Ainley Farm Environmental Impact Study: Addendum

Prepared for Black, Shoemaker, Robinson, Donaldson

Date: 24 July, 2019

Appendix 1. Response Matrix for GRCA Comments dated July 31st, 2018

Figure 1: Ecological Land Classification, Wetland Locations, Wetlands and Woodland Boundaries

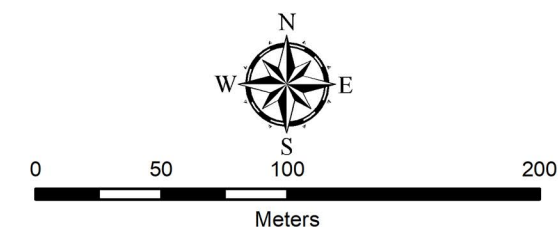
6. As indicated in the 2014 GRCA response to the Terms of Reference, the wetland boundary should be staked in the field then confirmed by GRCA staff. This work should be completed between May and October. The appropriateness of treating portions of the wetland feature as anthropogenic wetland should be confirmed while in the field.	Wetland and woodland boundaries were staked on September 4, 2018 as discussed in Section 2

Wetland and woodland boundaries were surveyed in areas in proximity to proposed development by a hand-held GPS on September 4th, 2018 (Garmin GPSMAP 64csx, accurate to 3.6m), with Ryan Hamelin of Grand River Conservation Authority (GRCA). Boundaries determined during the field visit (as well as the other ELC boundaries) are shown on Figure 1.

Figure 2: Proposed Development and Constraints

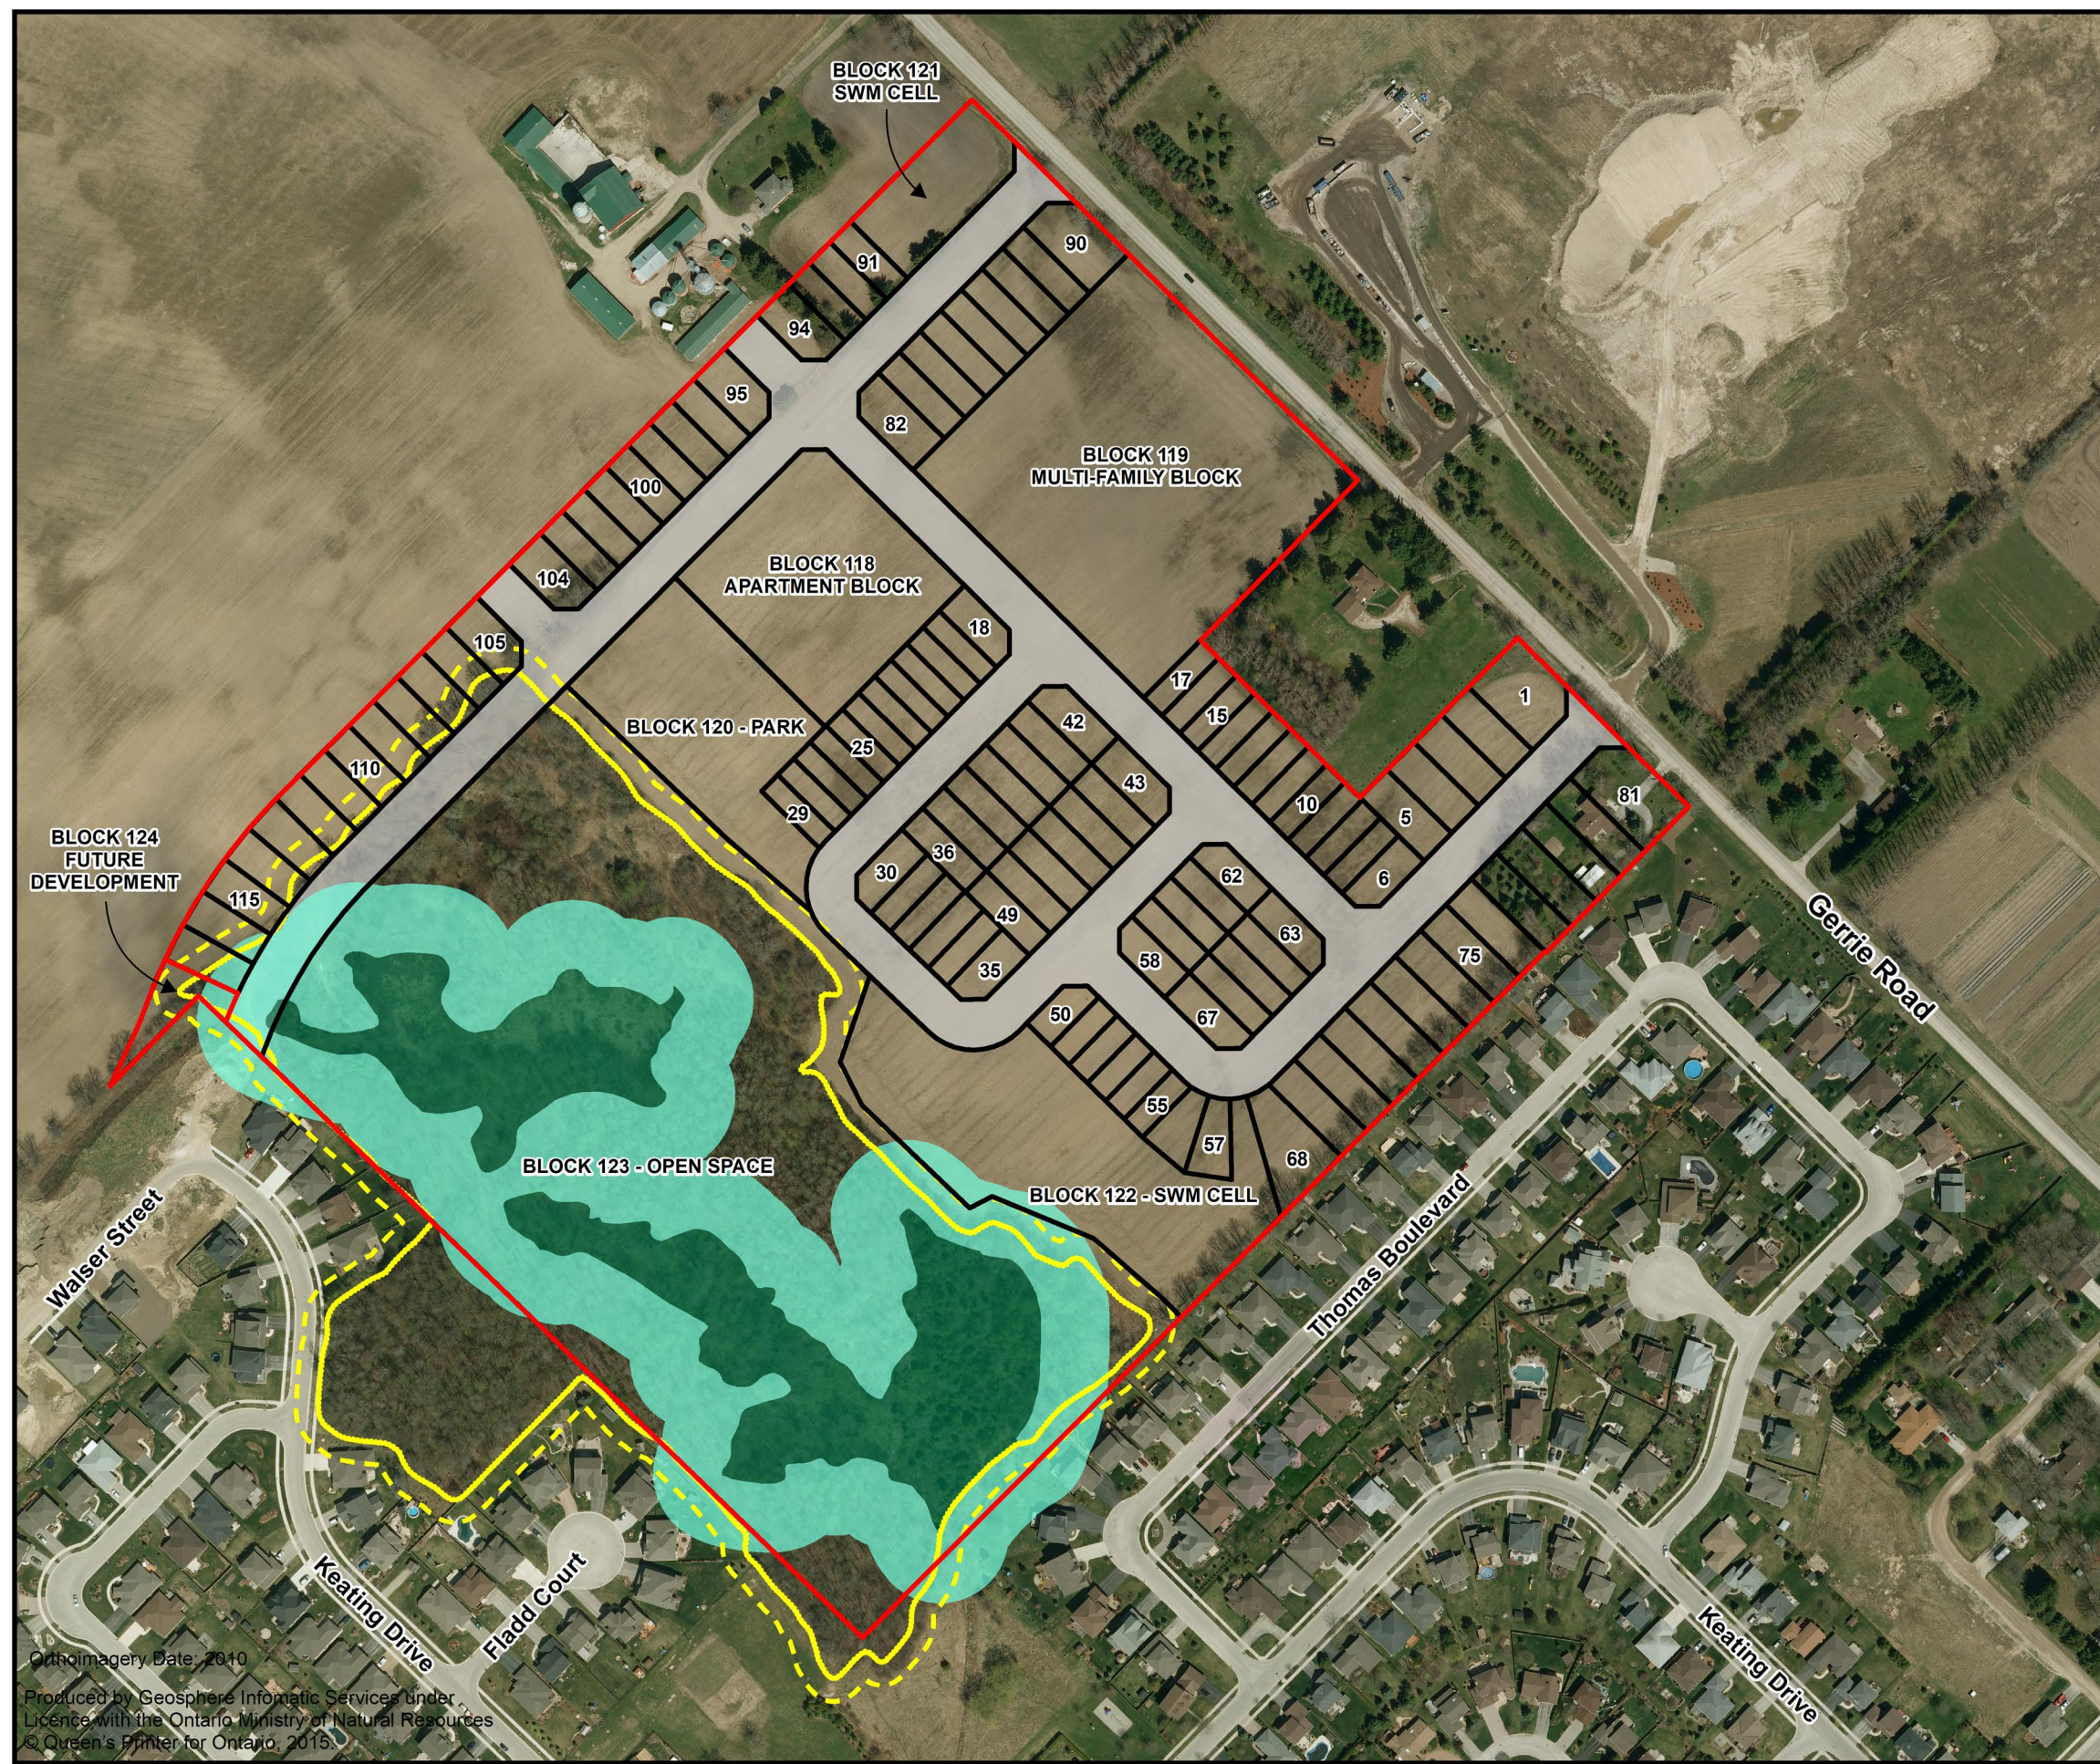
9. The EIS does not provide sufficient rationale for the proposed wetland buffer and buffer encroachments. Please provide additional rational for the buffer limits and any encroachments.	The site plan has been revised to provide additional setbacks as discussed in Section 6 of the EIS Addendum. Rationale for revised minor encroachments is provided in Section 6. Mitigation for encroachments is described in Section 7 of the EIS Addendum

The site plan has been revised to provide the following environmental setbacks, as shown in Figure 2:

- 10 m buffer to woodland dripline;
- Setback of between 30 m and 12 m from the southeastern wetland boundary.

Development of the storm cell is proposed within a small portion of the Area of Interference for the southeastern wetland. The area proposed for development has been used in the past for intensive agriculture, and is regularly ploughed each year. The proposed storm cell development is not expected to cause additional impacts, with mitigation in the form of restoration. Proposed restoration for this area is addressed in Section 7.
